**SUBJECT: Campaign #117 – Add Driveshaft Close-out Panel**

## INSTRUCTIONS TO PERFORM CAMPAIGN 117

**Unsecured Slideout Wire Harness  
(View looking toward front of chassis)**

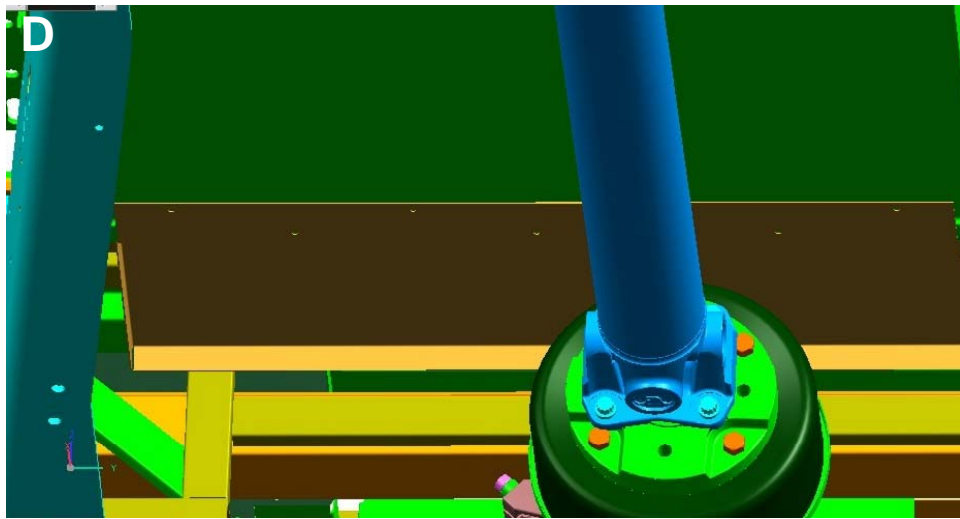
1. Inspect slideout wire harness and ensure that there is no damage. If the slideout wire harness is not damaged, proceed to Step 2.

*NOTE: If damage has occurred to the slideout wire harness, contact Tech Service at (866) 653-4329 for direction.*

2. Place the slideout wire harness above existing close-out panel. See Photo A.

3. Install the driveshaft close-out panel to cover the slideout wire harness underneath the chassis. Center the driveshaft close-out panel between the two chassis frame rails and attach to existing close-out panel. See Photos B, C, and Illustration D.
